Re: Compliance Test Notification for New Combustion Turbines at Intercession City
DEP Permit Number AC49-203114

SUBJ: Florida Power Corporation, Intercession City - Construction Permit
Modification

Re: Request for Construction Permit Modification
DEP Permit Number AC49-203114 ; PSD-FL-180

Peak Load Velocity Profile

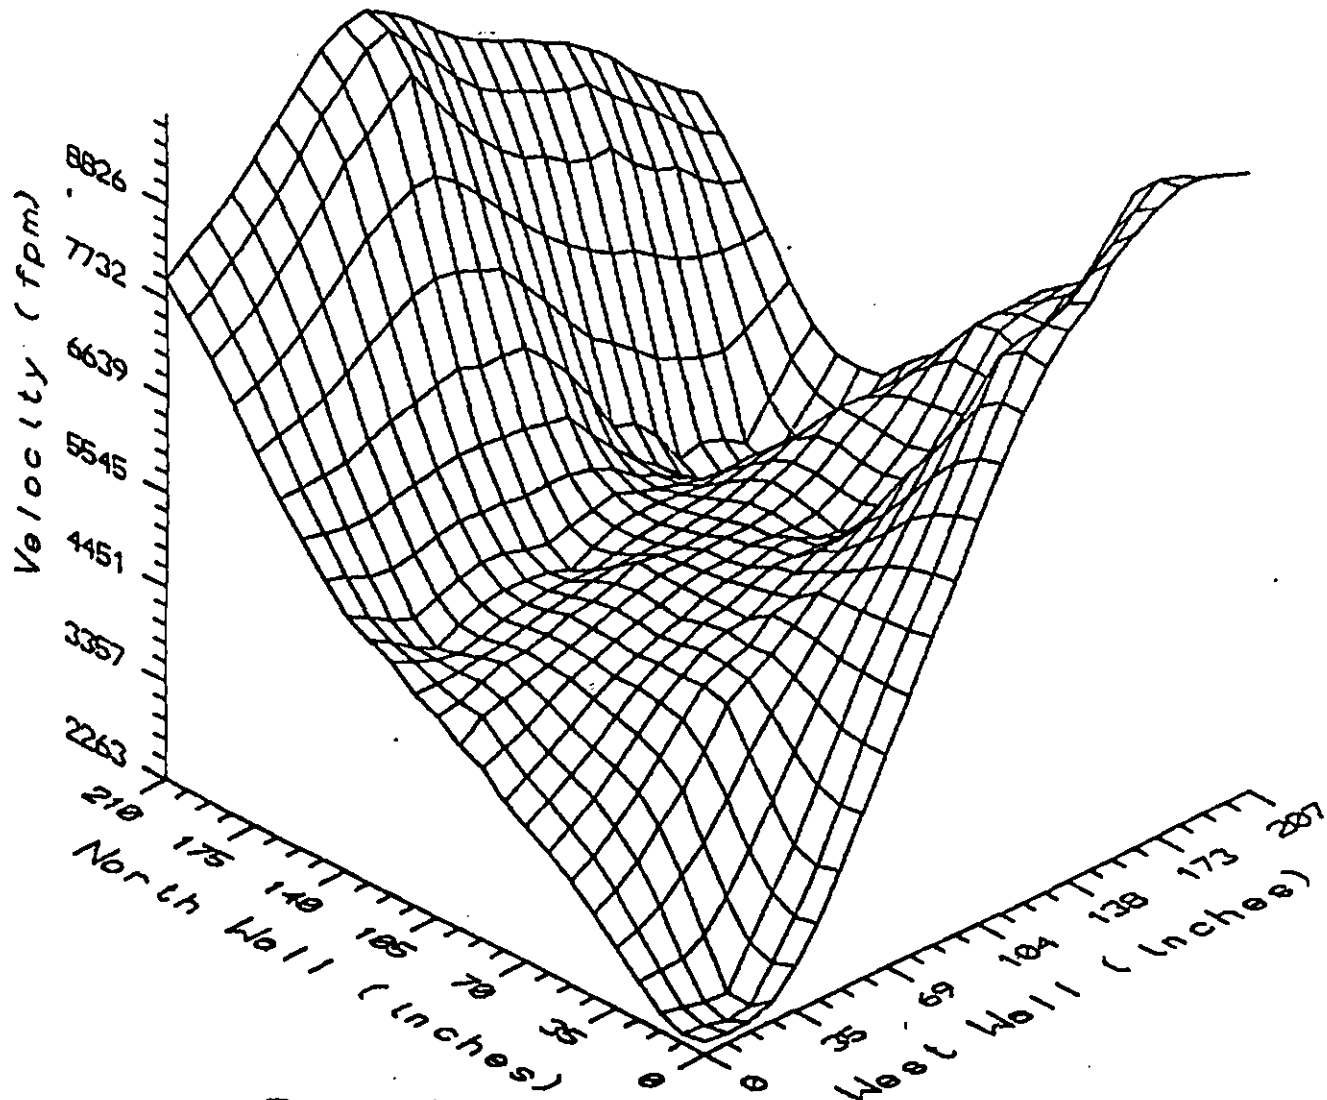
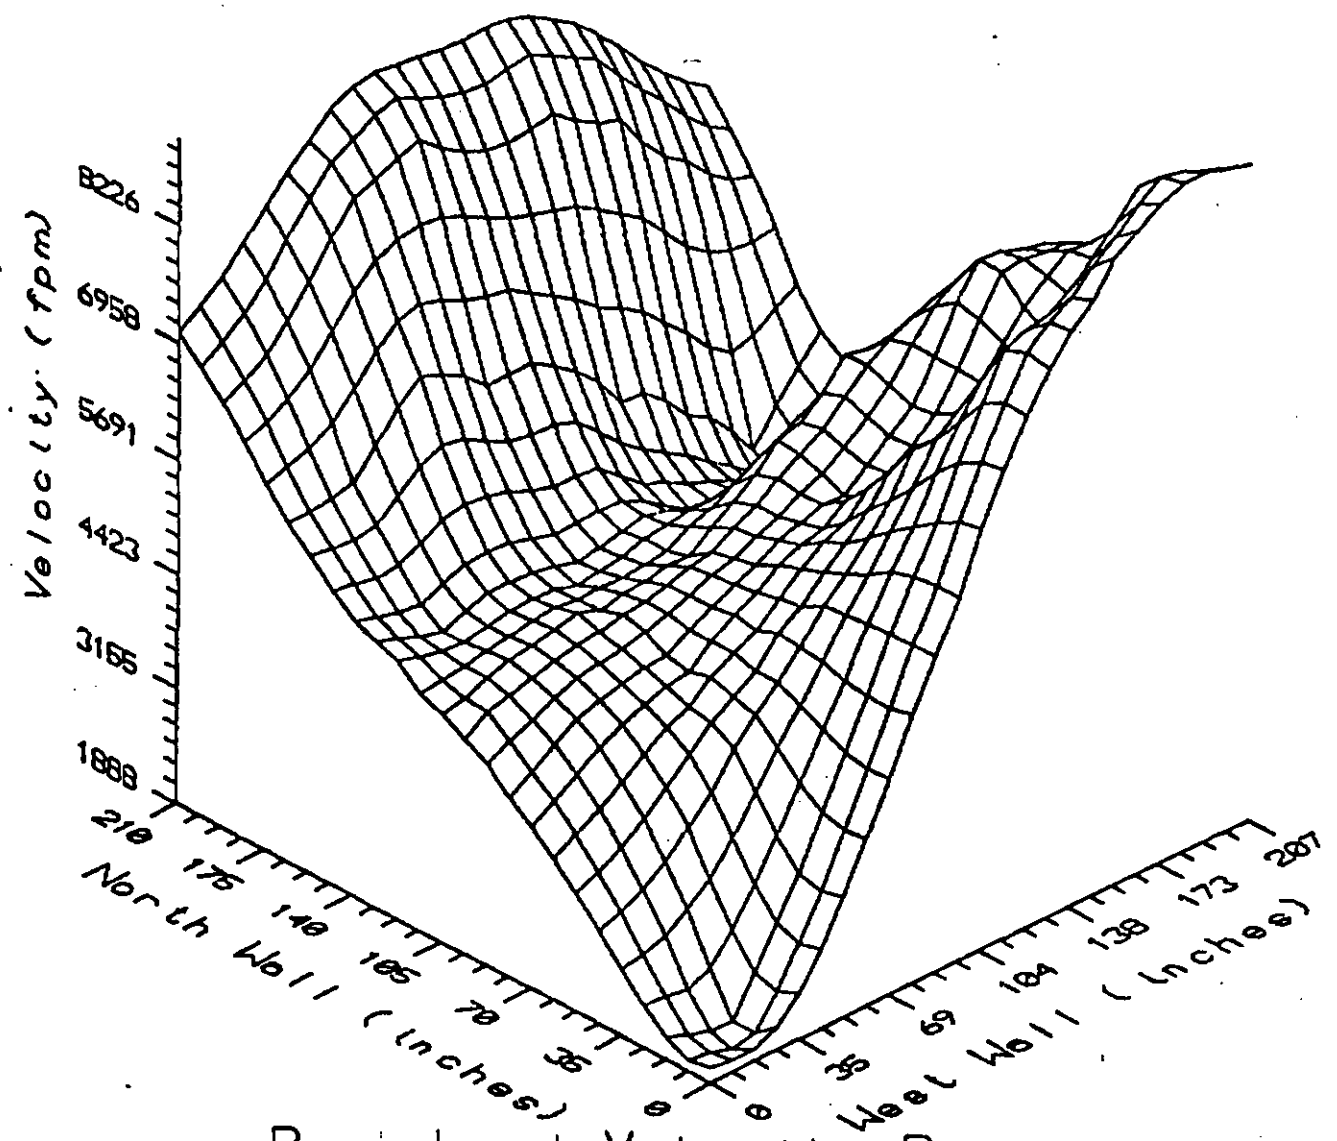
These conditions summarize the compliance test methods to be used. As provided by DEP Rule 17-297.620, FPC requests that EPA Method 19 be specified in place of Method 2 for determination of volumetric flow rate. Because of extremely turbulent flow in the exhaust gas stream of these combustion turbines, the pitot tube system of measurement specified in Method 2 is inaccurate. Method 2 is designed and intended to be used under laminar flow conditions, which do not exist in the exhaust stream from these turbines when operating at peak load. The International Organization for Standardization, in Section 12.2.2.2 of "Measurement of Fluid Flow in Closed Conduits - Velocity Area Method Using Pitot Static Tubes" (ISO 3966), describes the error of the method due to turbulent flow. It states "The error increases with the increasing degree of turbulence of the measured fluid flow and is always positive, i.e. the measured velocity value is always greater than the actual flow velocity."

Method 19 results in a more accurate and precise measurement of the gas flow in cases in which turbulent flow conditions exist. Please refer to the attached report from GE, which is the manufacturer of the turbines for both the DeBary and Intercession City sites.

As shown above, use of the calibrated bellmouth airflow method and US EPA 40 CFR 60 Method 19 provide the most accurate airflow measurements and are GE's preferred methods. Comparisons with US EPA 40 CFR 60 Method 2 show unacceptably high variability.
